Town of Lancaster
Board of Appeals
Lancaster, Massachusetts 01523

Memorandum

Re: Comprehensive Plan: 0 Sterling Road

Petitioner: Crescent Builders, Inc.

Updated since 4/25/19 meeting:

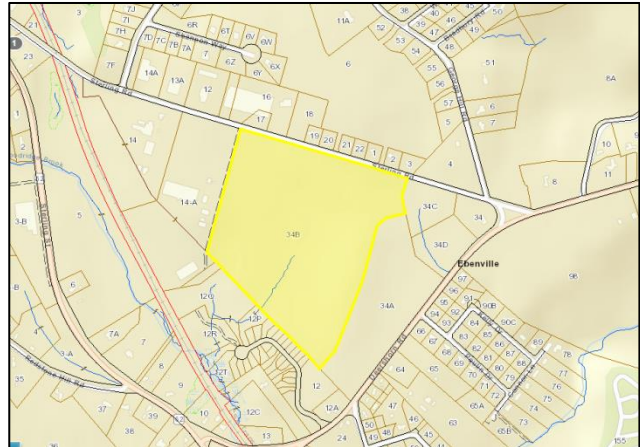
- The applicant provided a boulevard style median strip on the driveway for the multi-family site.
- Reconfigured the parking for the multi-family use to incorporate the “proposed future parking” from the previous plan and to move the fire truck turning circle to the end of the parking rather than in the middle.
- The applicant provided updated stormwater calculations as a result of the parking changes.
